1. Residential Design/Development Review: Canyon Springs Estates Lot 21, Sean and Ann Keightley

To: Planning Commission
From: Thomas Dansie, Director of Community Development
Date: August 13, 2020
Re: August 19, 2020 Town Council Meeting
Residential Design / Development Review – Canyon Springs, Lot 21

KEIGHTLY RESIDENCE

VIEW CORRIDOR
STUDY

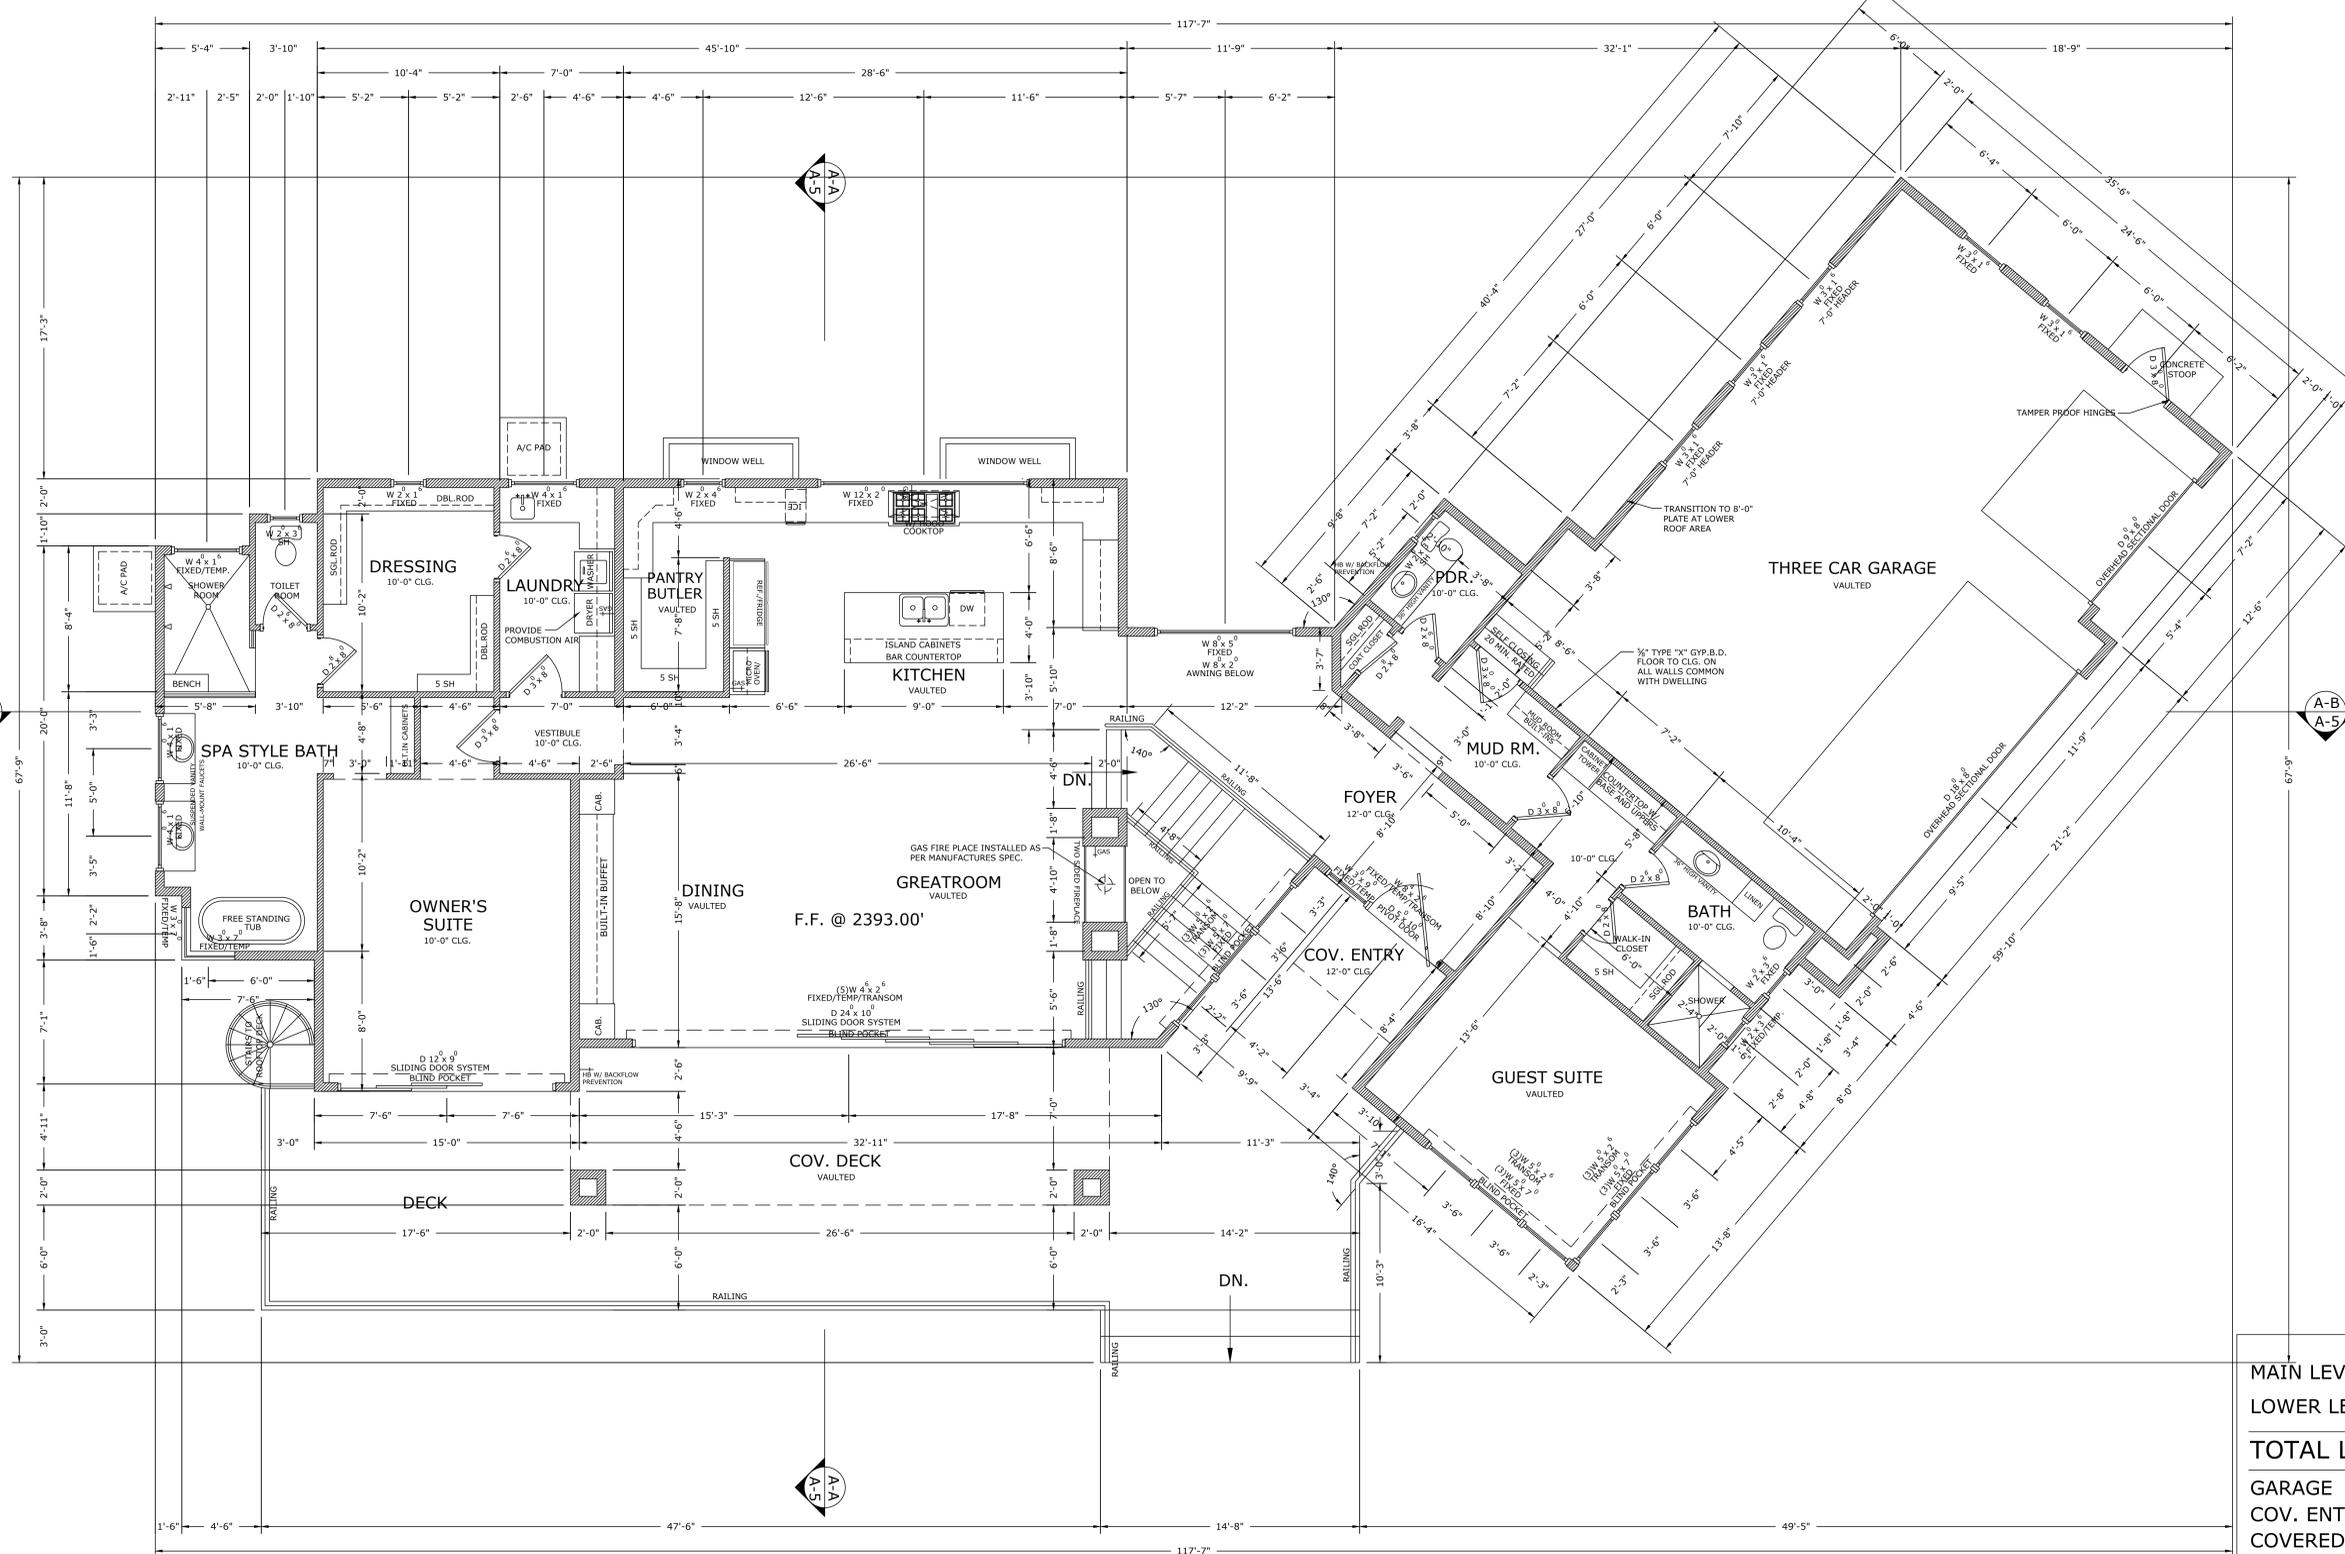
I would like to apprise the commission that the image with the line drawing of the Keightley Residence overlaid on it entitled View Corridor Study (Page 11 in the Town's package, and labeled C-1.2 on architectural drawings) is misleading because the sketch of the home location is completely out of place on the image. In order to properly register the line drawing with the underlying image, the left-most edge of the line drawing should shift up on the page to align the curve and asphalt "parking spot" at the upper left corner of the image. With this registration error, the location indicated on that image labeled "View Corridor" is out of place.

MAIN LEVEL FLOOR PLAN

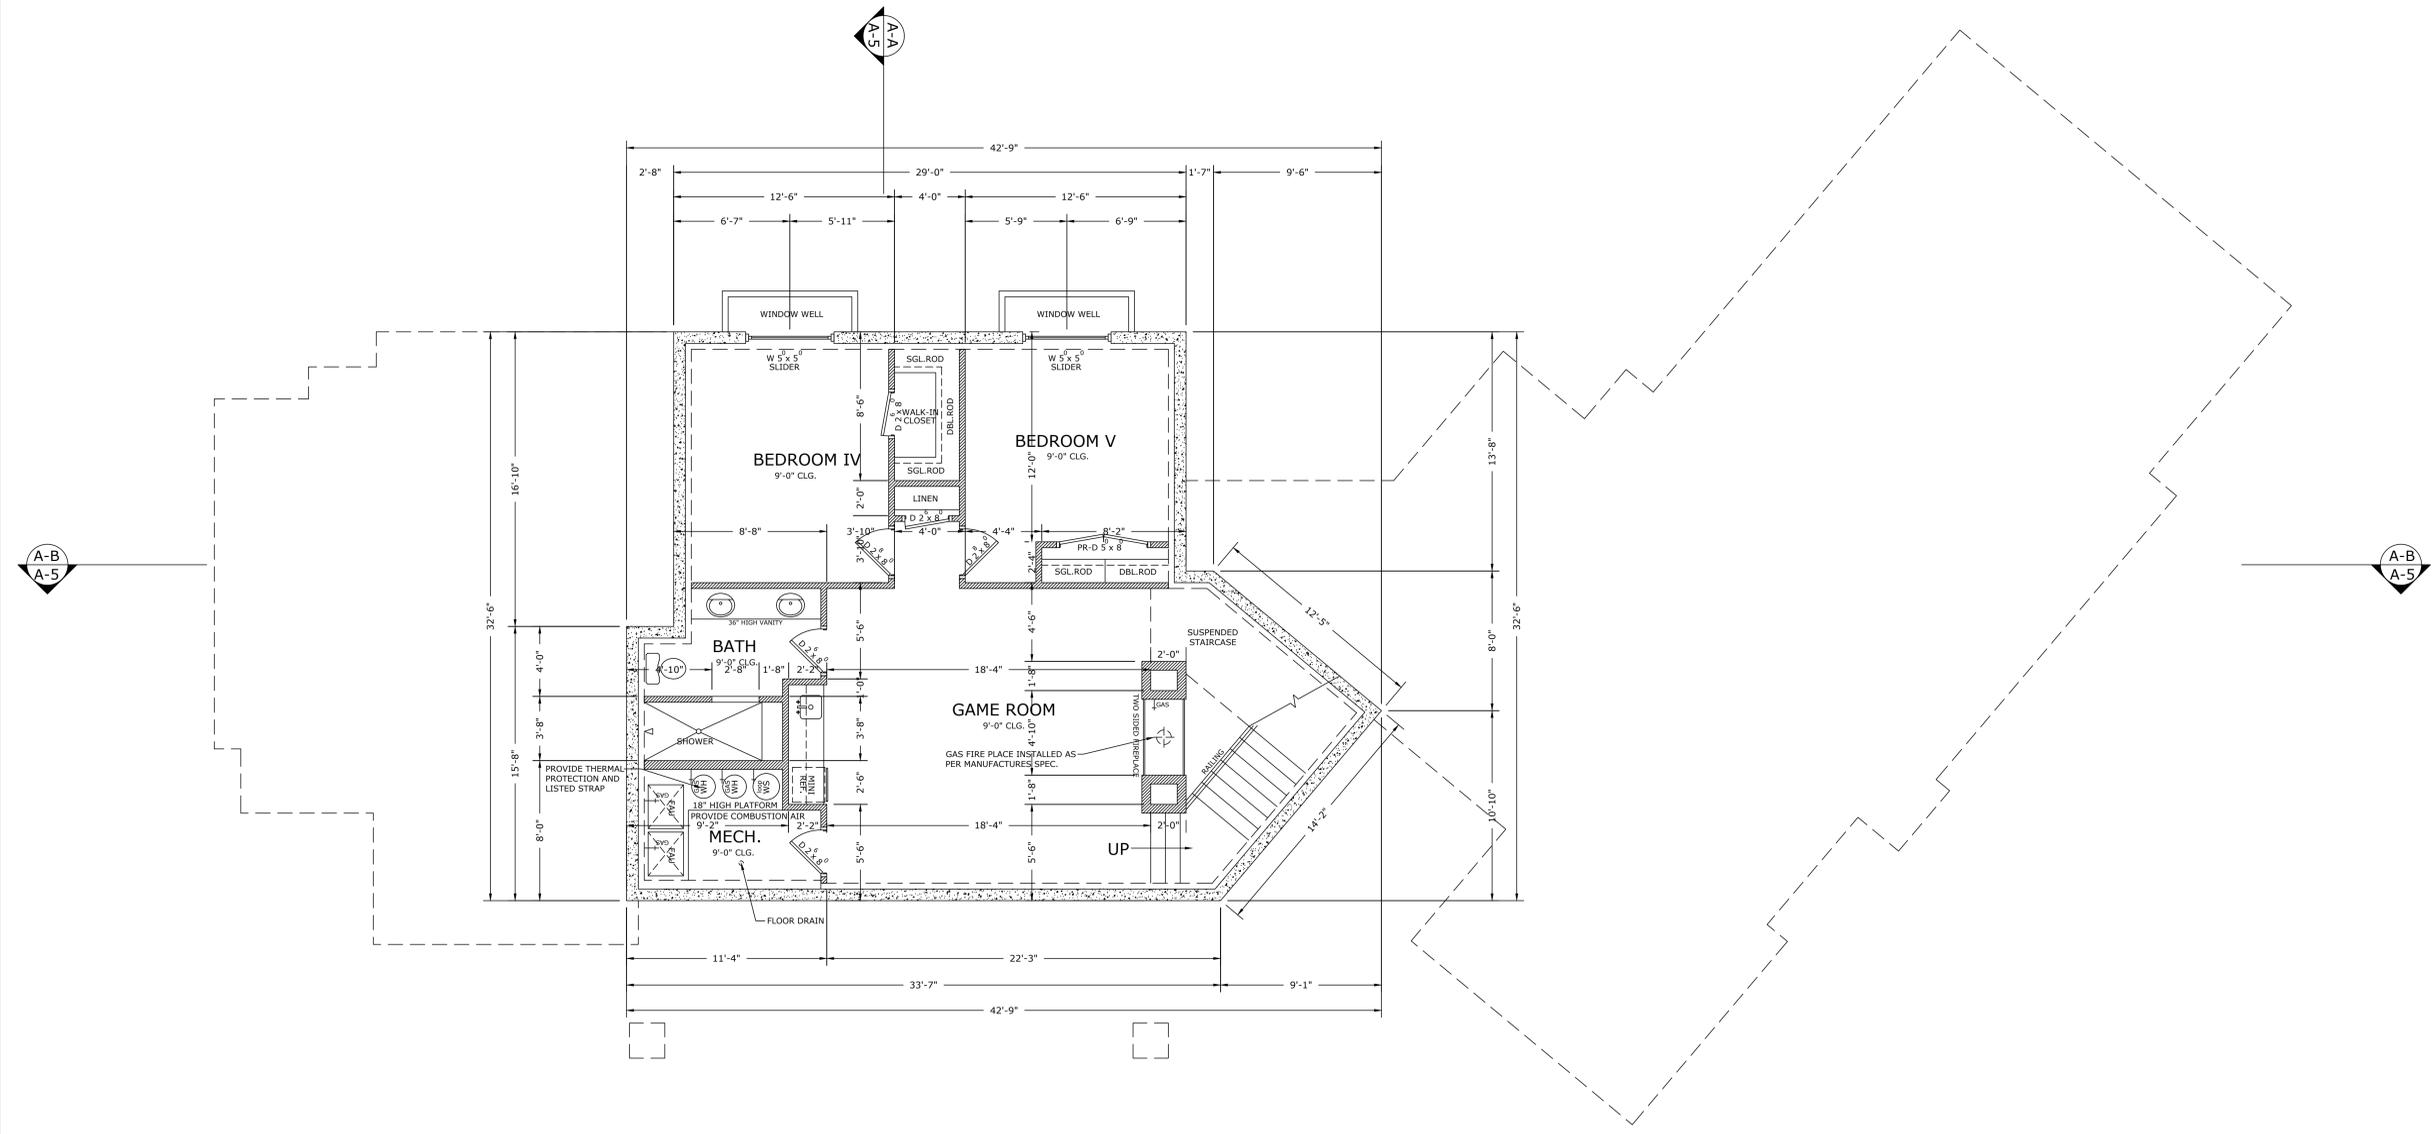
Page 12 of the package (Page A-1 Main Level Floor Plan) indicates that the A/C PAD will be placed outside of the Shower Room of the Owner's Suite. However, there is no screening indicated in the plans to limit the noise disturbance made by the mechanical equipment. This location for the A/C PAD is the closest point that the Keightley residence is sited in relation to the existing neighbor residence (S-CASE-22). Therefore, it is imperative that adequate sound deadening be installed or that the A/C PAD be relocated to a less obtrusive location, such as to the nook outside the garage wall near the powder room. Chapter 10-9A-14 of the Town Code lists Special Regulations and Requirements pertaining to development in the Foothill Residential zone. In particular, Section E. Mechanical Devices; Screening: Air conditioners, heating, cooling and ventilating equipment, propane tanks, swimming pool pumps and heaters, and all other mechanical devices shall be screened as necessary from the surrounding properties and streets or lanes, and shall be operated so that the resulting sound does not exceed the applicable sound control levels as set forth in town ordinances.

ROOF OVERVIEW

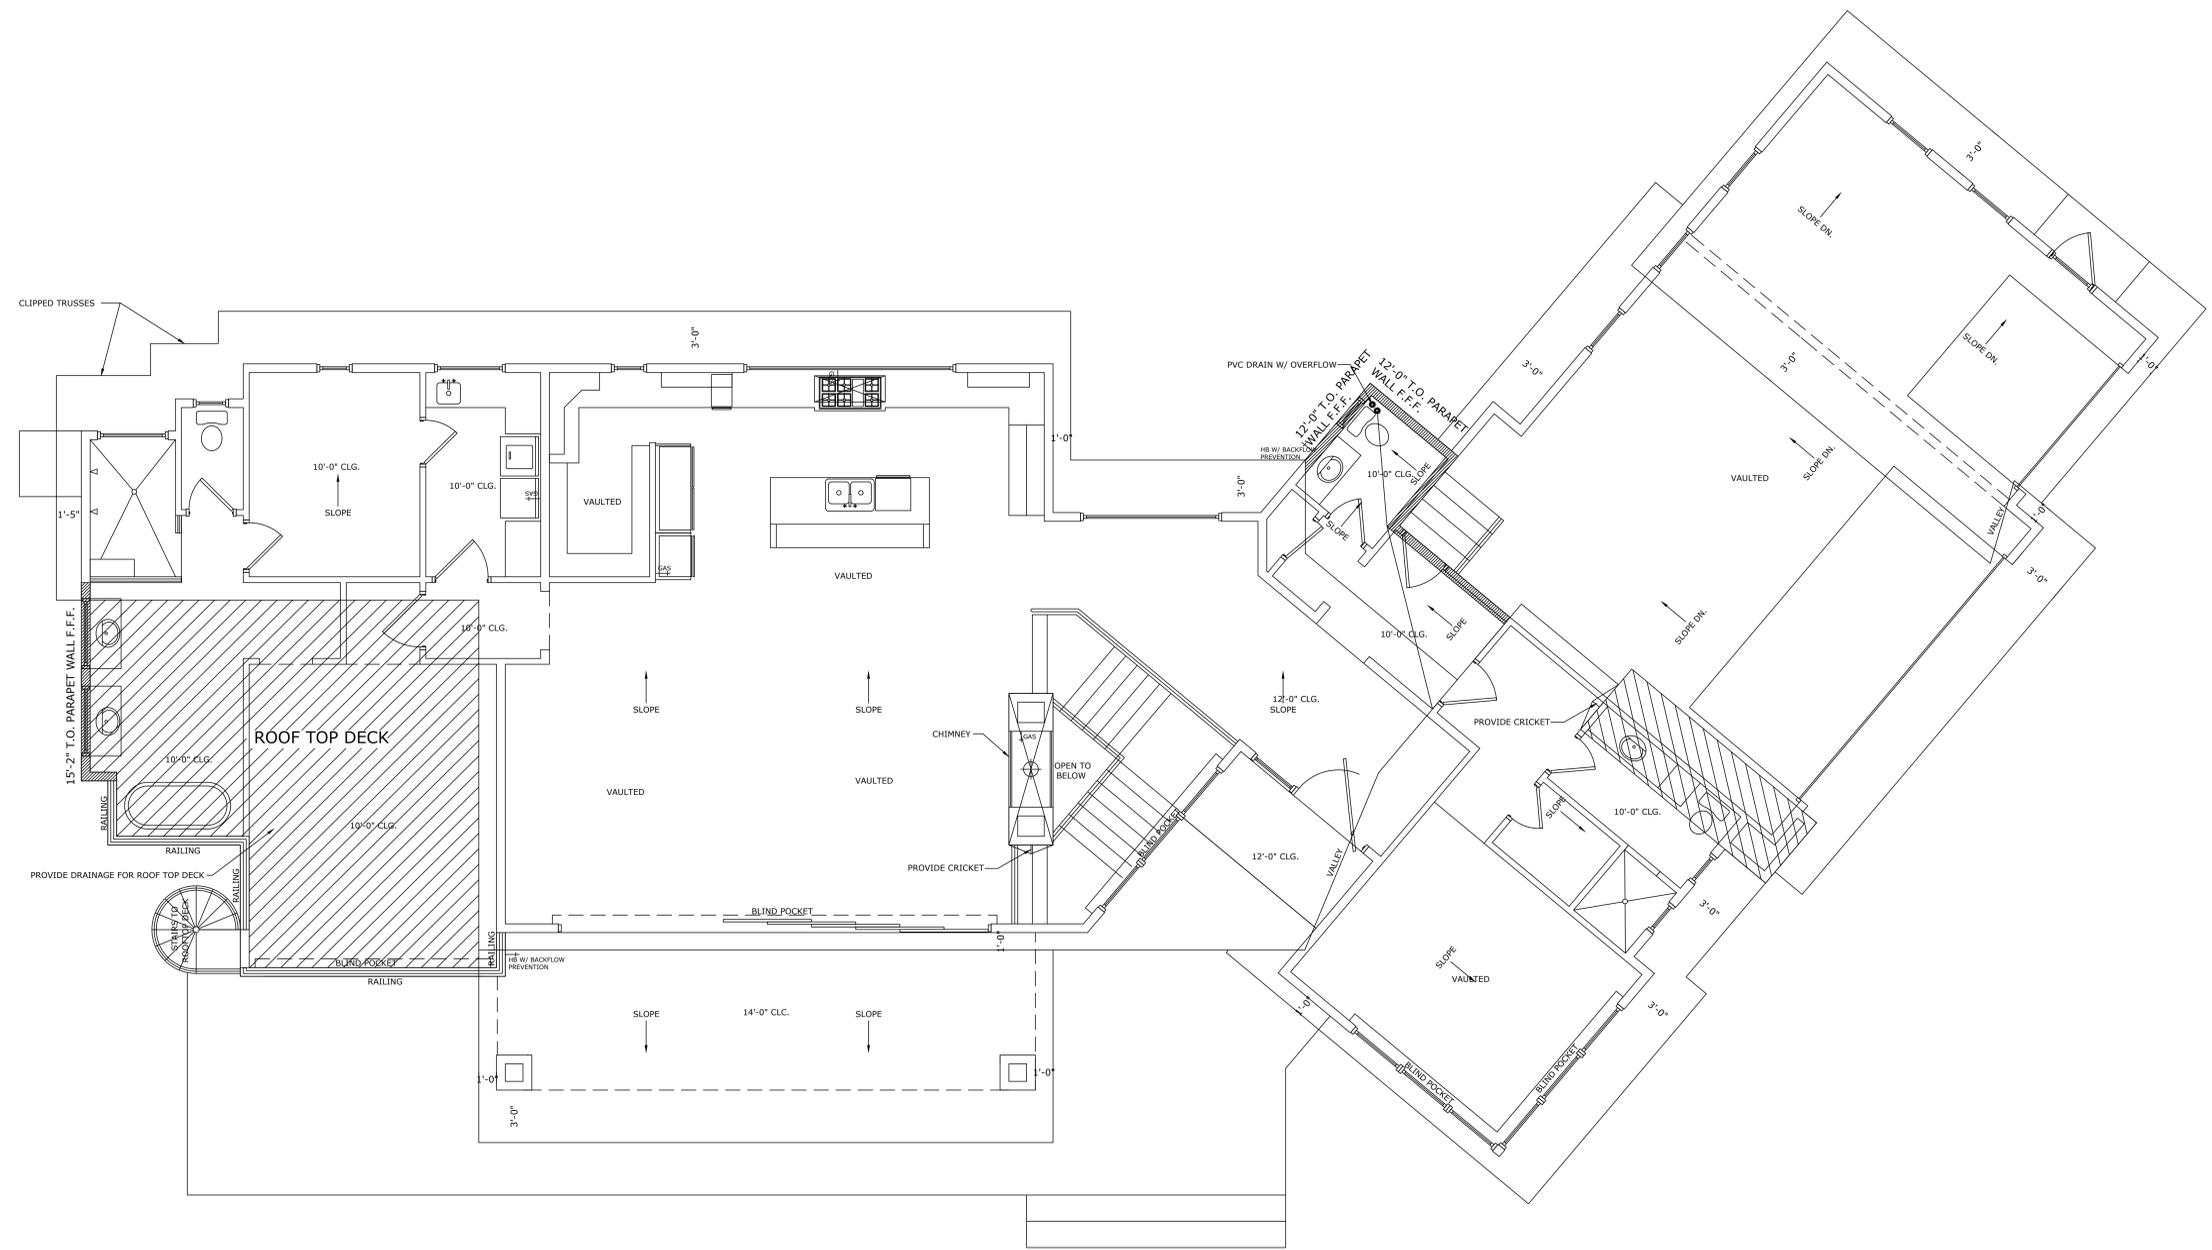
Lastly, the location of the Roof Top Deck on the Keightley home is also in very close proximity to the existing neighbor residence (S-CASE-22) and might be considered an invasion of privacy on that neighbor. That, as well as the location of the lot near the base of Johnson Mountain will also reflect all noise (especially music and even slightly above normal conversation levels) toward other neighbors on Canyon Cove. For these reasons, I ask that you consider not allowing a roof top deck on this residence.

That said, we have one significant concern, and that is regarding the proposed rooftop deck. Most of us lucky enough to build a home in Springdale do so for the peace, quiet and solitude that the Park and surroundings provide. It is for the following reasons that Odet and I strongly object to inclusion of a rooftop deck in this design:

1. In designing our home, we were exceedingly mindful of maintaining privacy to adjacent lots, such that a future home on either side of us would not feel as though we looked upon them. This was particularly the case with lot 21, as we sit 5-6 feet higher in elevation. We minimized our windows to that lot, and strengthened that privacy by a tall block wall running along our entire west elevation (see attached photo). This was done as a respect and courtesy to our future neighbors. For similar reasons, our primary outdoor space is surrounded by walls on 3 of 4 sides. We seek reciprocal consideration and courtesy.

2. The proposed rooftop deck essentially becomes an open second story, which is counter to the one story restriction on this lot, and chief reason we had confidence in being able to maintain privacy when purchasing our lot 14 years ago.

3. This second story deck is huge, would hover 7-8 feet above/just west of us, and would be a direct intrusion into our living space, privacy and solitude.

4. Our canyon locale transmits noise very, very readily. One can hear conversation 150 yards away. Given these conditions, elevating a large gathering space 12'-13' into the air makes it a potential stage for the wide broadcast of conversation and din from parties that would be unwelcome and unfair to neighboring homes.

5. The views that this rooftop space would afford are not meaningfully different from the views already amply afforded by the expansive porch just below which spans the entire front elevation of this home. Omitting the rooftop deck does not compromise the design in any way. And on a positive note, its omission simplifies the design and reduces cost.
